# Model Error Resolution Document

1. Document Number: MDL-NBS-HS-000006	2. Revision/Addendum: 03/01	3. ERD: 04
--	--------------------------------	---------------

4. Title: UZ Flow Models and Submodels	5. No. of Pages Attached: 48
---	---------------------------------

Figure J-3. Water Table Temperature Contour Plot

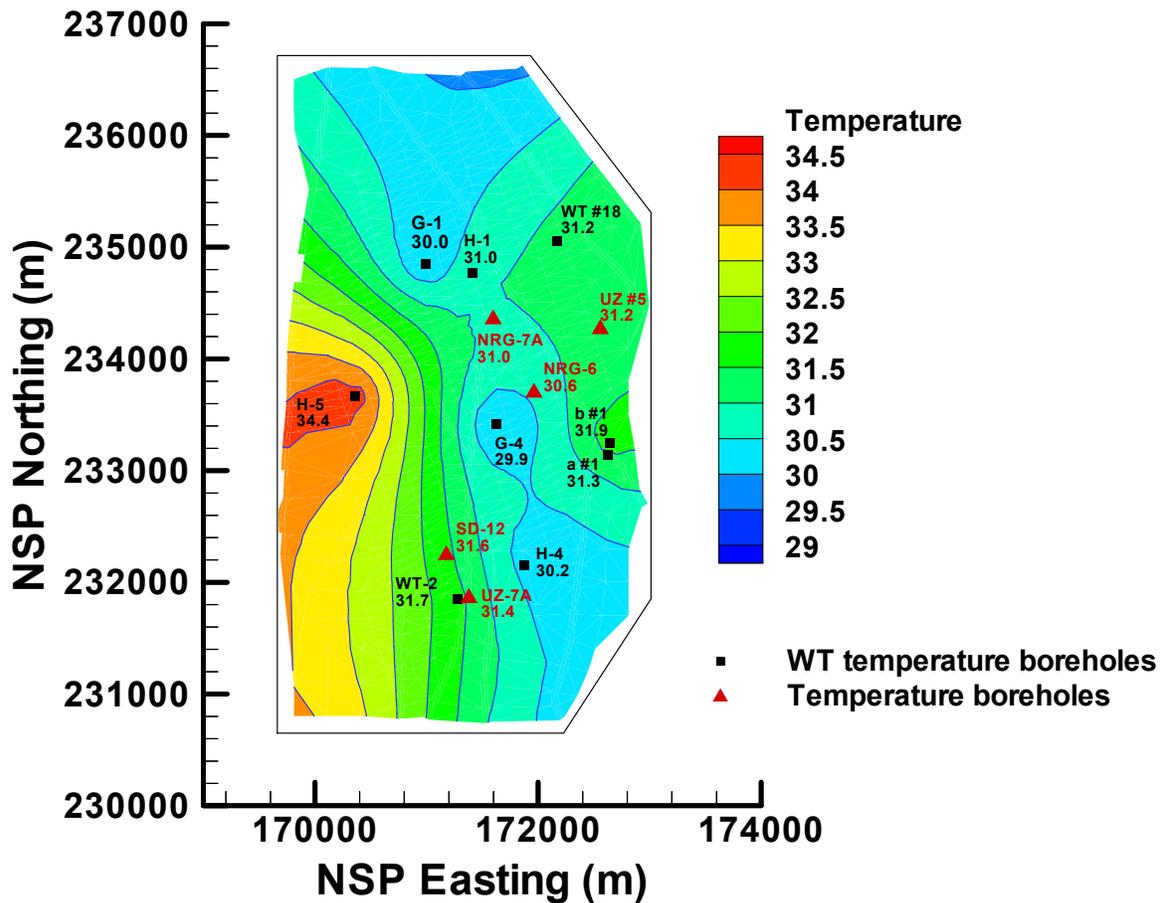
The water table temperature map in Figure J-3 is a direct interpolation of the water table temperature measurement data and therefore is not affected by calibration to infiltration model output, unlike Figure 6.3-7 of the main report. This water table temperature map is used in the following sections for ambient temperature calculations instead of the map shown in Figure 6.3-7 of the main report.

Figure J-15. Chloride Concentration (mg/L) Profiles at Borehole USW NRG-7a for Present-Day 10th, 30th, 50th, and 90th Percentile Infiltrations

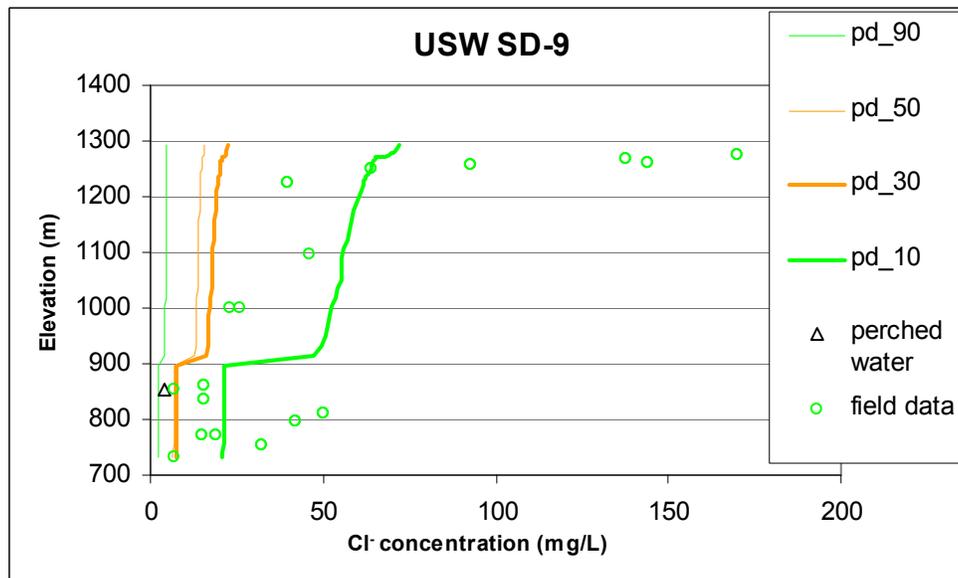
During the course of investigation for CR-11715, it was determined that Figures 6.5-3 and 6.5-4 of the parent report show incorrect source DTN information; DTN: GS020408312272.003 [DIRS 160899] should be removed from the list of data plotted in these figures. Similarly, DTN: GS981008312272.004 [DIRS 153677] should be removed from the list of data plotted for Figure 6.5-7. The plots of chloride data and model results in Figures 6.5-7, 6.5-3, and 6.5-1 have some erroneous field data points, and are replotted in Figures J-15, J-16, and J-17, respectively.

Figure M-1. (from *Mountain-Scale Coupled Processes (TH/THC/THM) Models* (BSC 2005 [DIRS 174101]))

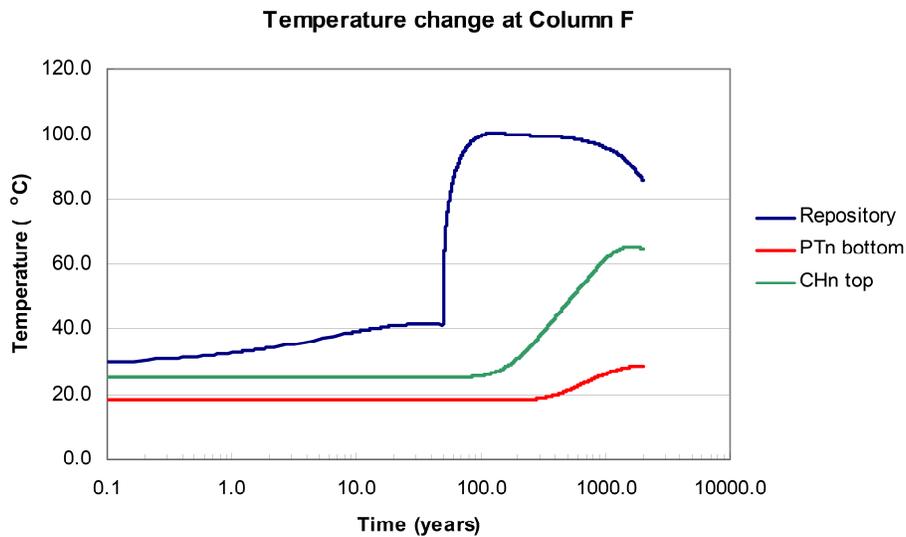
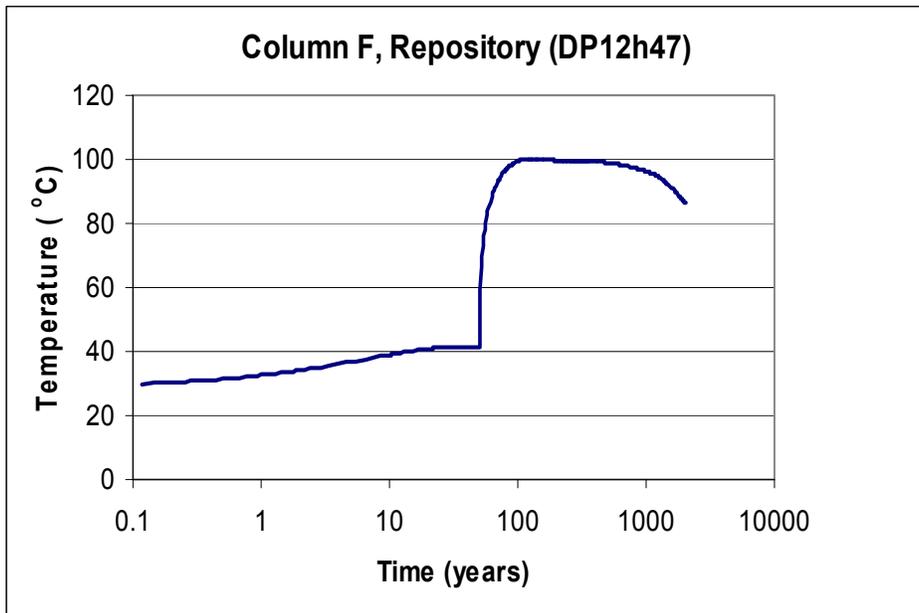
Note that there is a small discrepancy in the temperature plots at the repository for Figure 6.3.1-7 (BSC 2005 [DIRS 174101]) (reproduced here as Figure M-1), which used thermal properties from DTN: LB0210THRMLPRP.001 [DIRS 160799], and Figure V-5 (BSC 2005 [DIRS 174101]) (reproduced here as Figure M-2), which used thermal properties from DTN:

LB0402THRMLPRP.001 [DIRS 168481]. The discrepancy occurs near the time that ventilation is turned off at 50 years, where a sharp temperature rise occurs. The difference in these figures results from a lower time resolution for the data plotted in Figure M-1, which causes the sharp temperature rise to appear to start at an earlier time (prior to 50 years). Figure M-3 below shows data plotted from DTN: LB0310MTSCLTH3.001 [DIRS 170270], using output files GASOBS.DAT\_th\_v16.out\_1.txt, GASOBS.DAT\_th\_v16.out\_2.txt, GASOBS.DAT\_th\_v16\_2.out.txt, GASOBS.DAT\_th\_v16\_3.out\_1.txt, GASOBS.DAT\_th\_v16\_3.out\_2.txt, and GASOBS.DAT\_th\_v16\_3.out\_3.txt. These are the source files for Figure M-1. Figure M-3 is a re-plot of the time-temperature history for the repository cell shown in Figure M-1 using more data points at times near 50 years. Also, the plot stops at 2000 years, corresponding with the duration plotted in Figure M-2. Temperature versus time was extracted from these files for cell DP12h47, which is the repository cell for Column F (column h47 in the model grid, as identified in Table 6.3-1 of *Mountain-Scale Coupled Processes (TH/THC/THM) Models* (BSC 2005 [DIRS 174101])). The time-temperature data for cell DP12h47 in these files contains well over 100,000 points, so not all points are used in the plot below or in Figure 6.3.1-7 (BSC 2005 [DIRS 174101])). At times near 50 years, a higher time resolution in the data is required to resolve the sharp change in slope of the time-temperature curve for the repository cell. Sufficient data is available in the files from DTN: LB0310MTSCLTH3.001 [DIRS 170270] to better resolve the sharp change in the time-temperature profile at 50 years, however, the selected points used for Figure M-1 does not fully resolve this sharp change. The temperature history for the repository cell in Figure M-3 is seen to be essentially the same as the temperature history at the repository in Figure M-2. Therefore, these comparisons support the conclusion that the differences in thermal properties between DTN: LB0210THRMLPRP.001 [DIRS 160799] and DTN: LB0402THRMLPRP.001 [DIRS 168481] has a negligible effect on the calculated temperatures at the mountain scale.
